ADDENDUM

Project: **Crestwood School District
Crestwood High School
Field Building & Site Improvements**

Date: **March 29, 2023**

Addendum Number: **#3**

A1.11

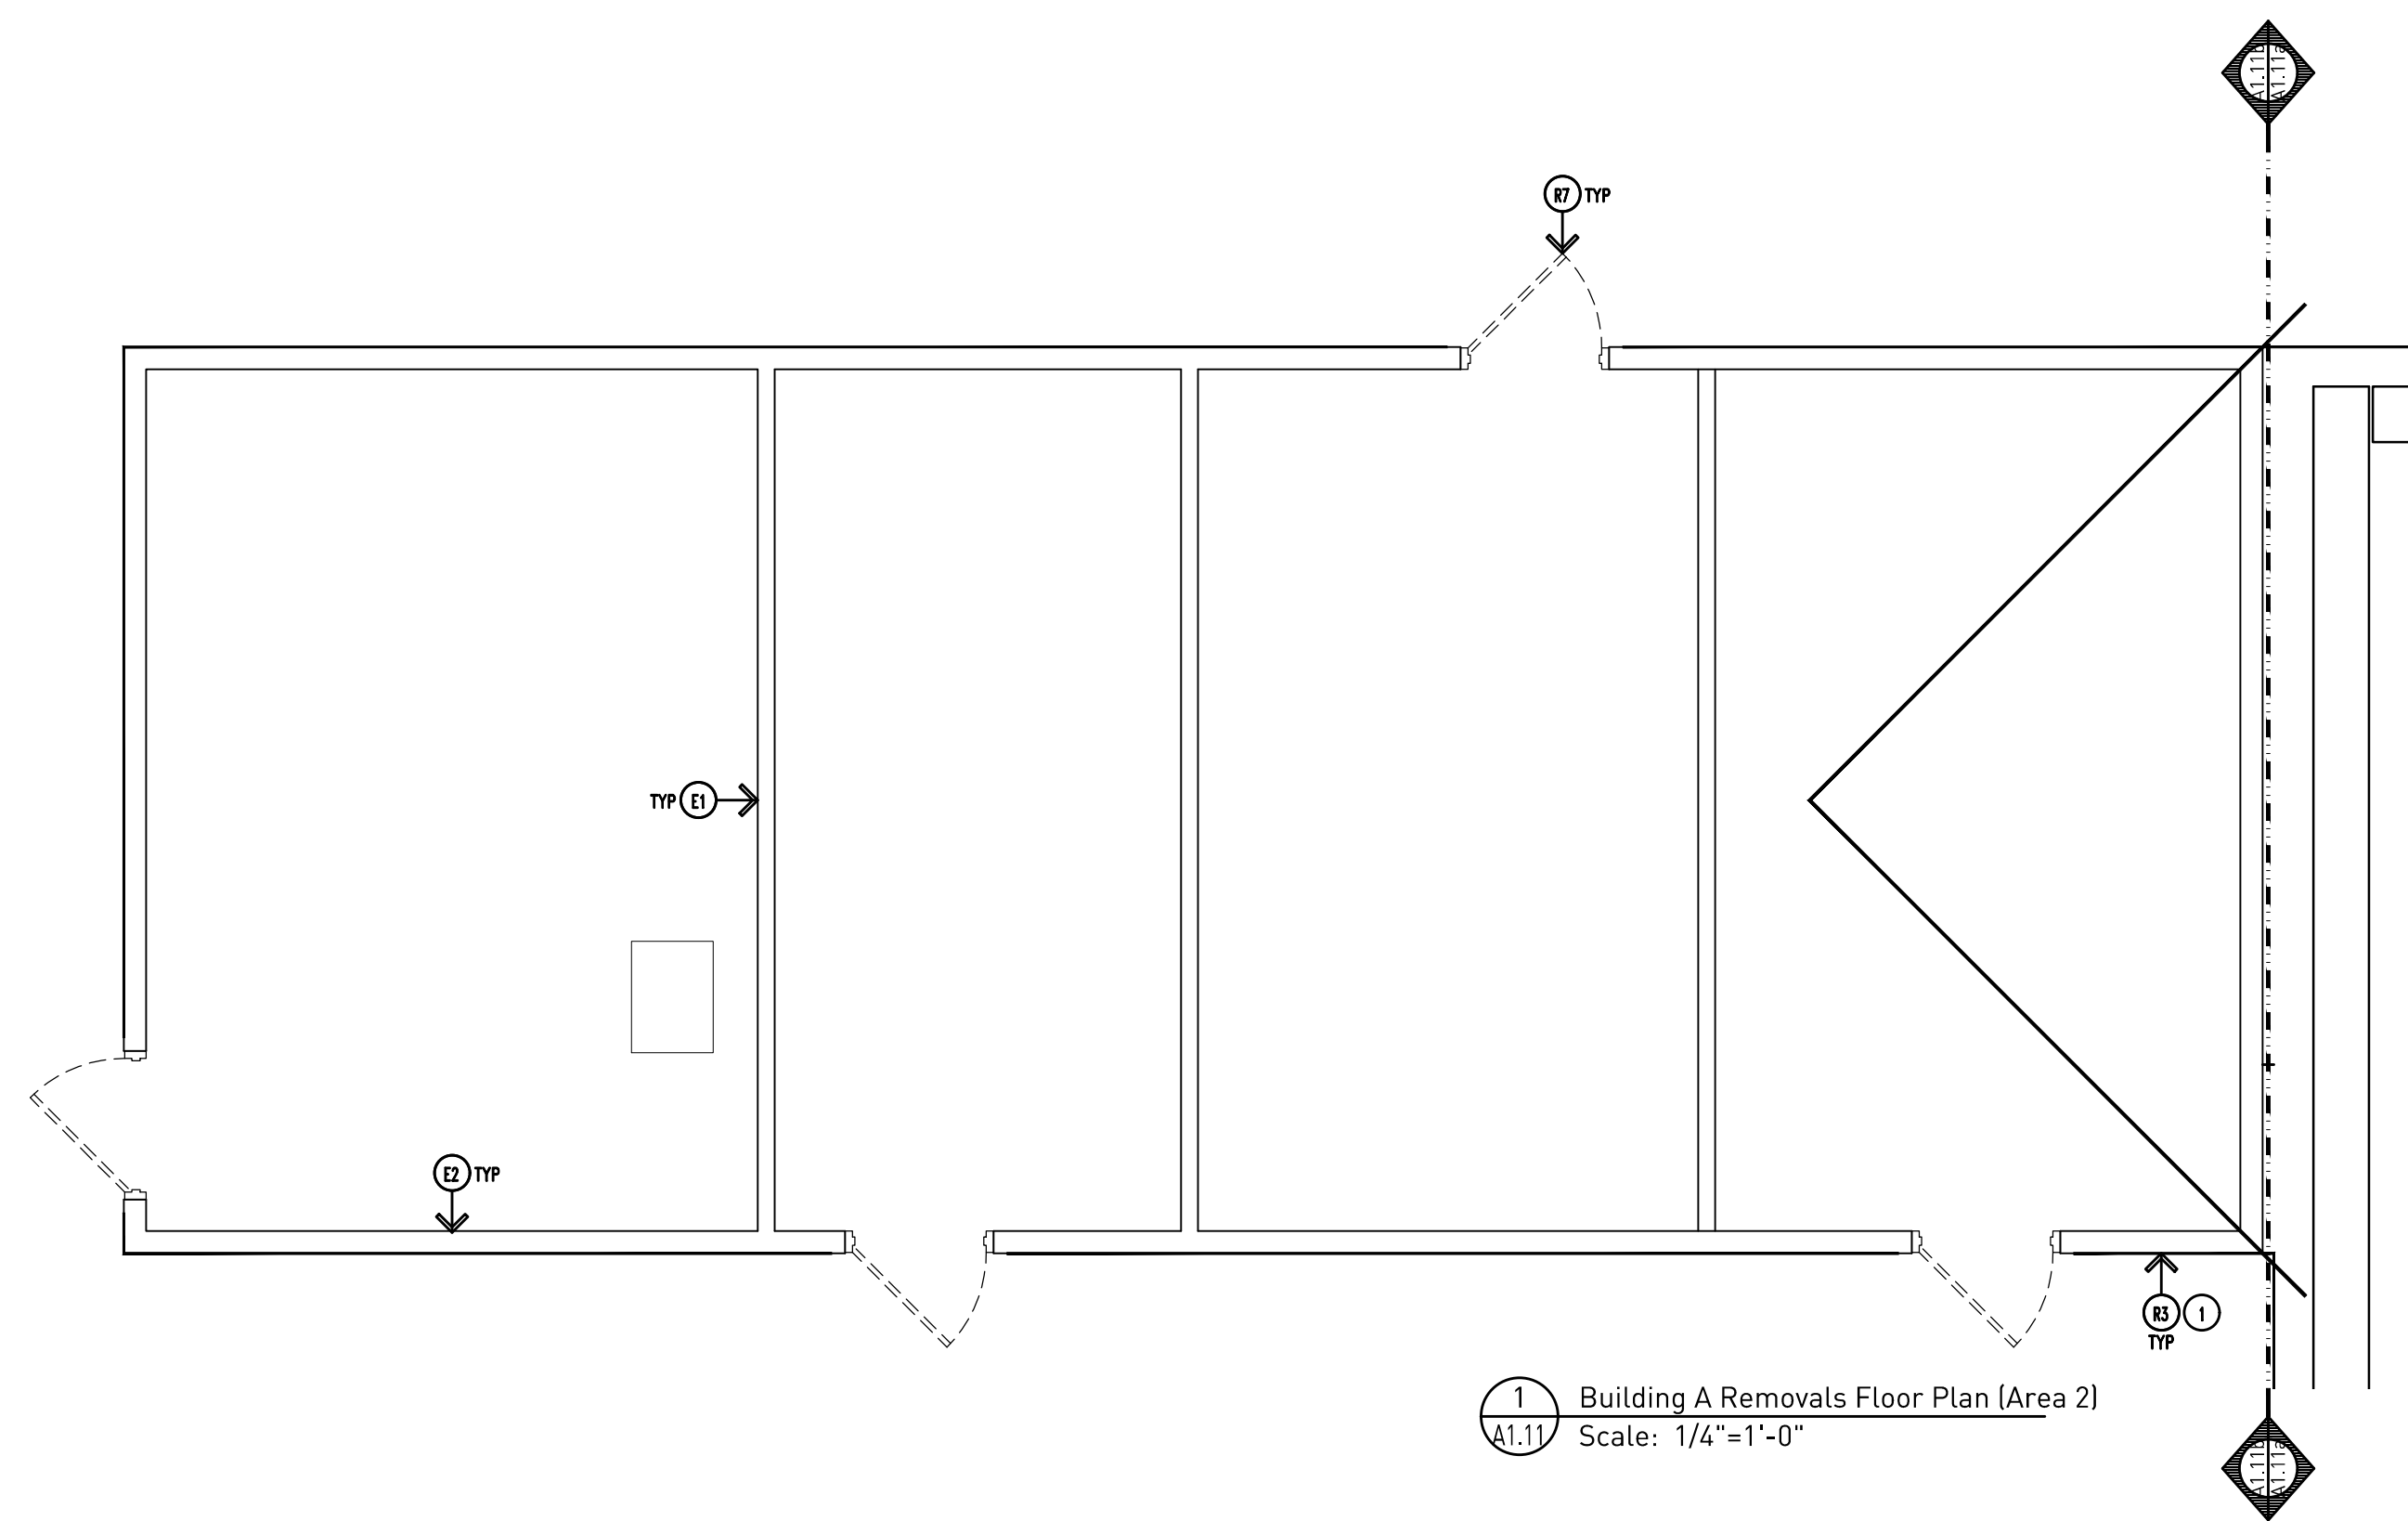
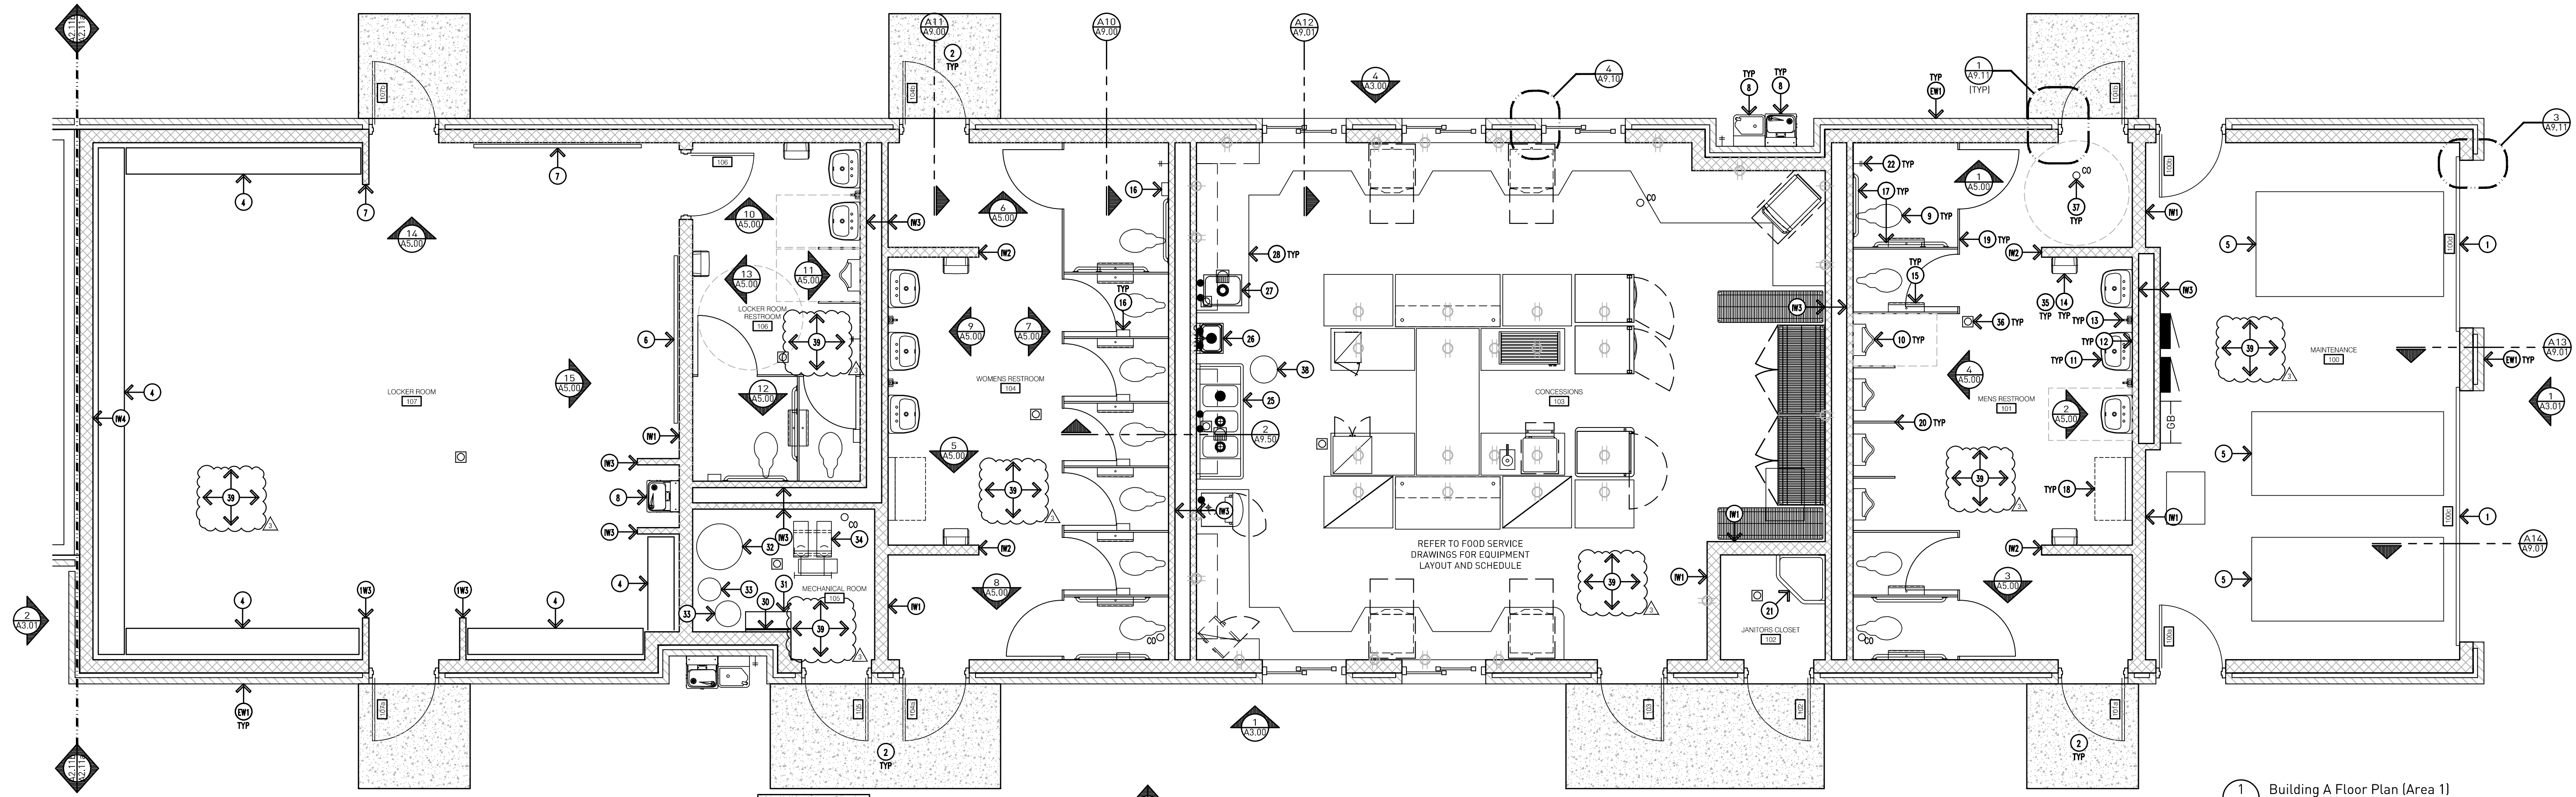
ADD: Note R19 – “Existing concrete floor slab – complete.”

ADD: Note tag R19 as indicated on detail 2/A1.11

A2.50

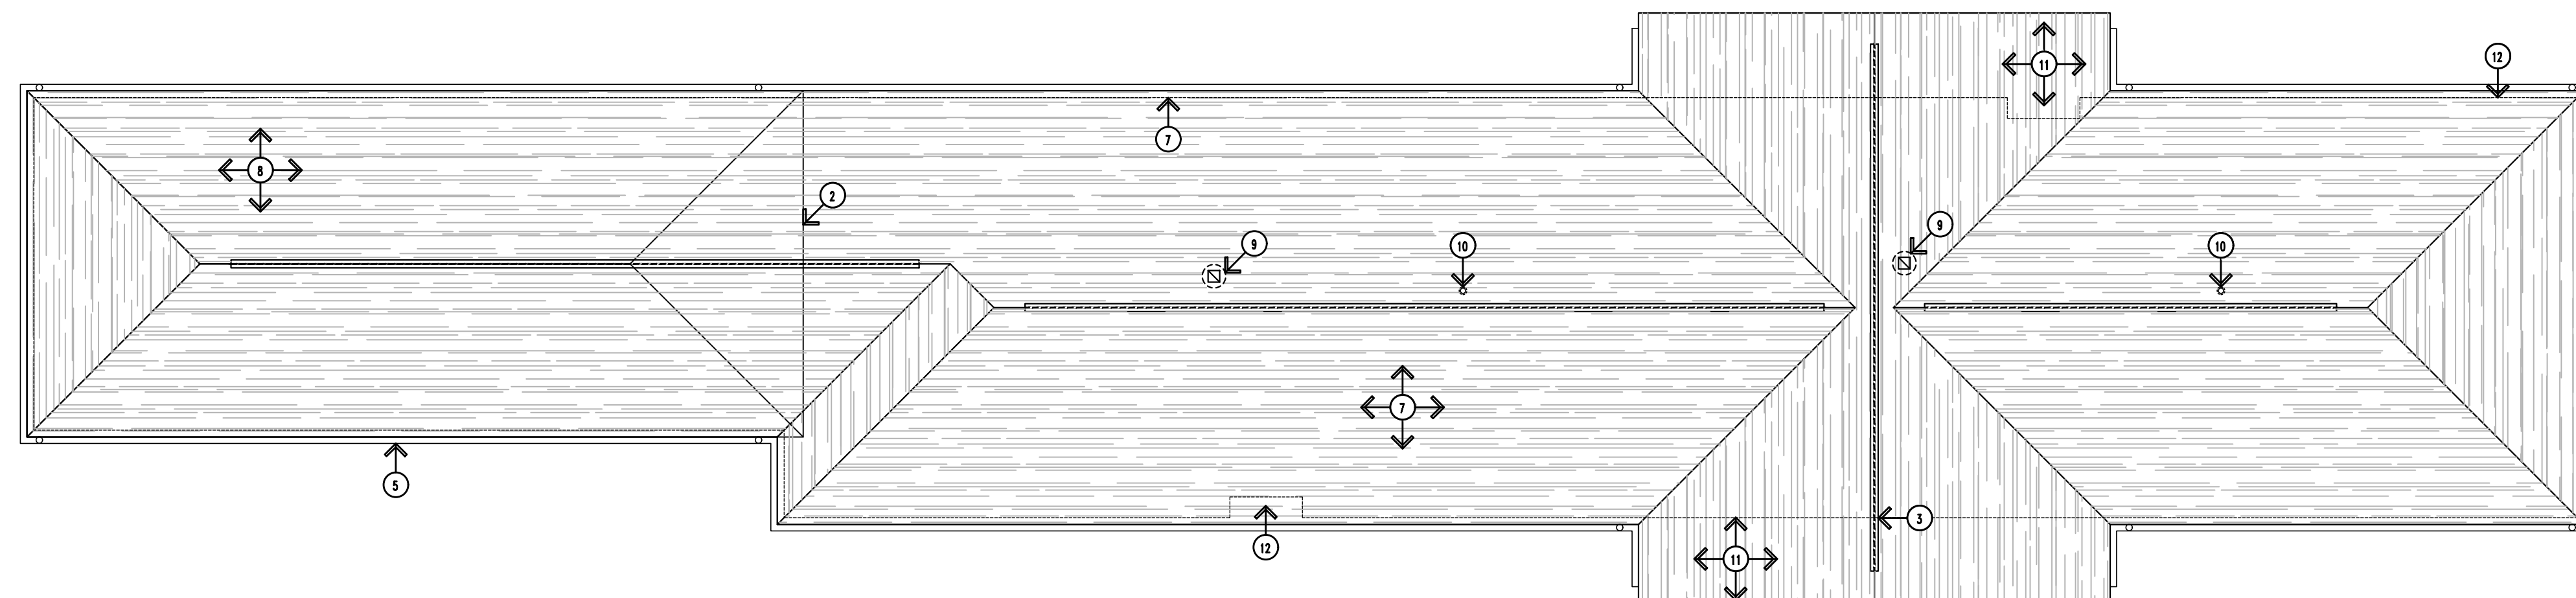
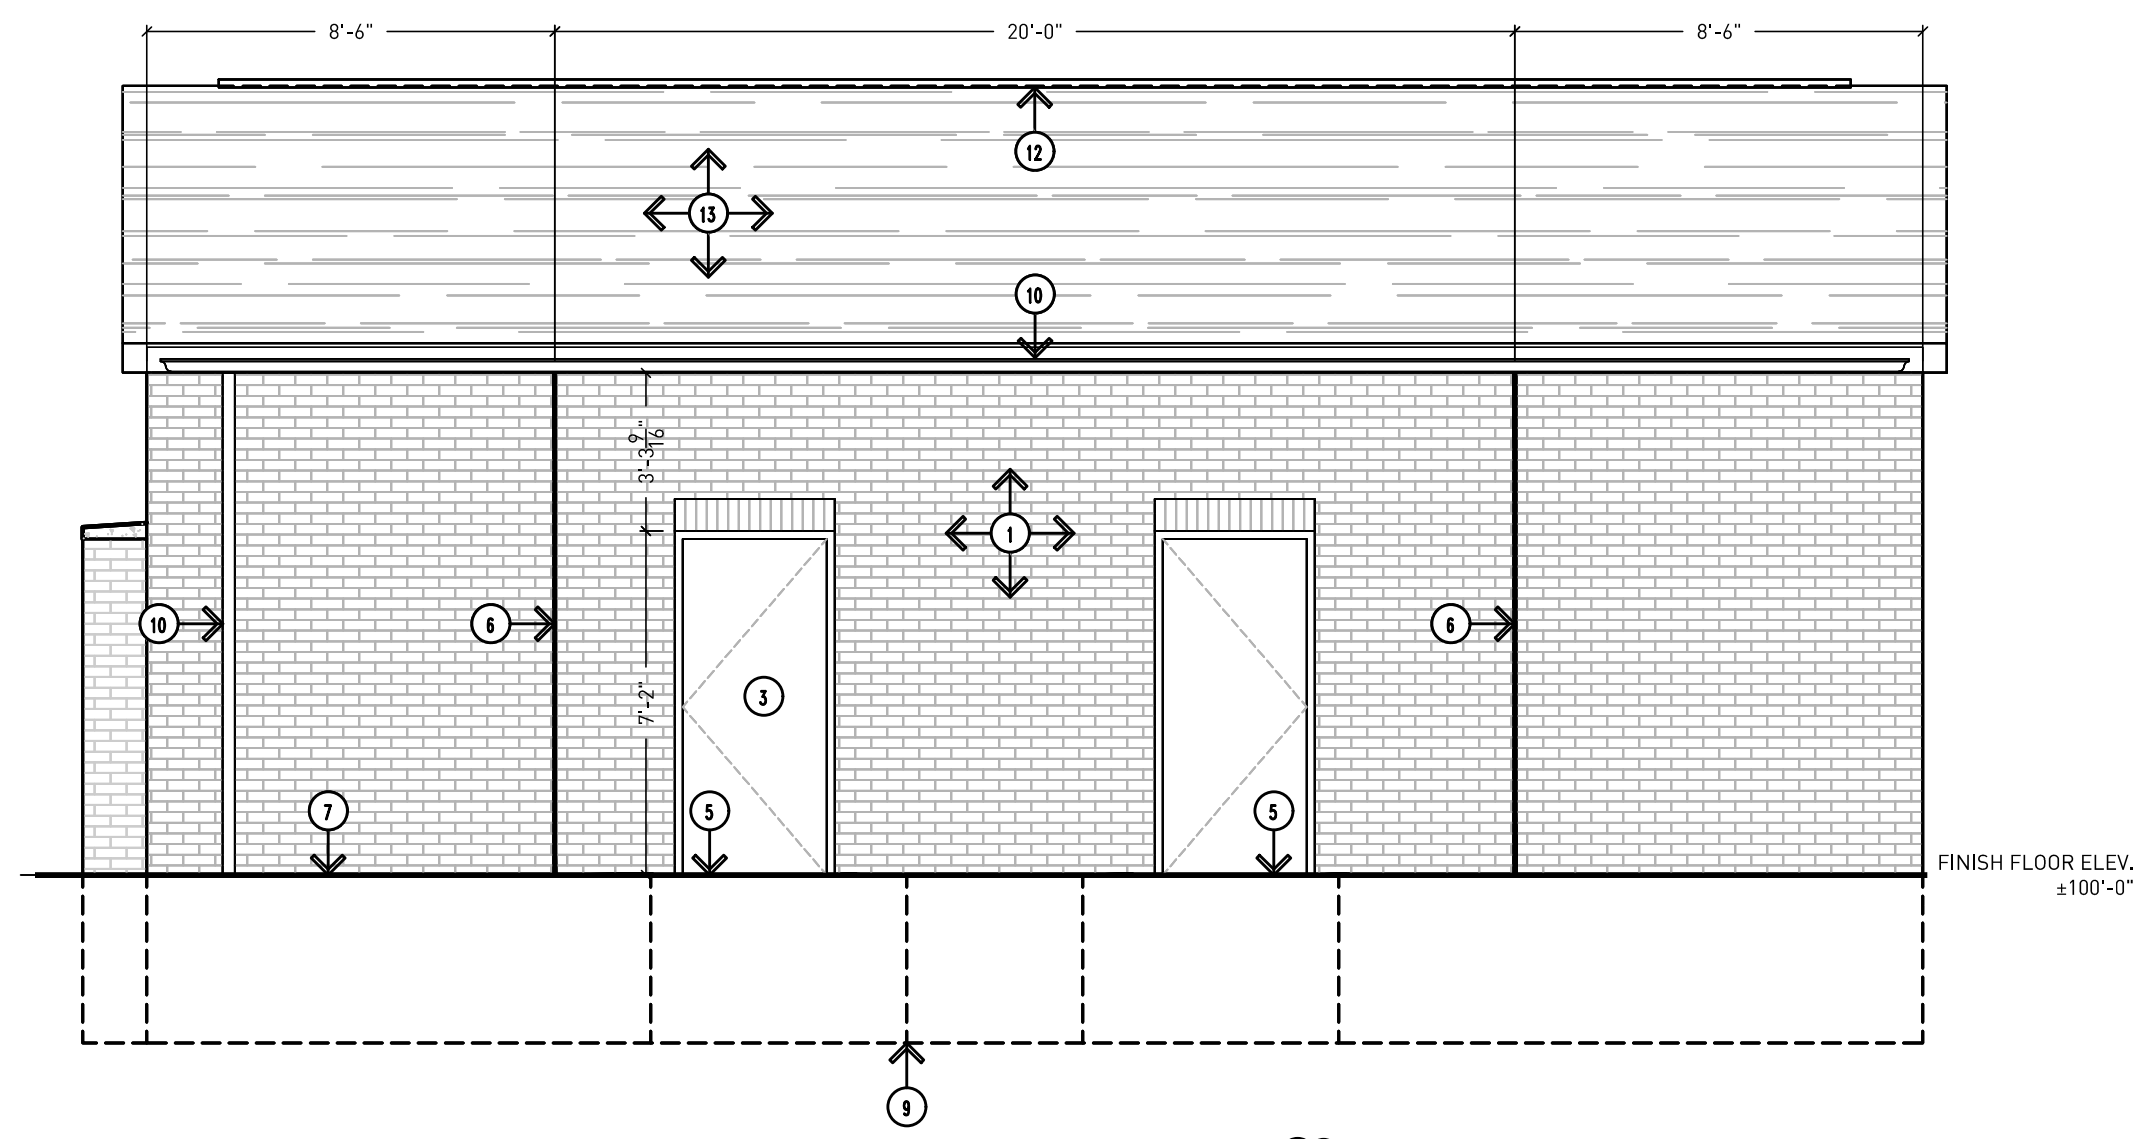
DELETE: Downspouts on Detail 2/A2.50 Building B Roof Plan

REVISE: Detail 2/A2.50 as indicated on sheet.
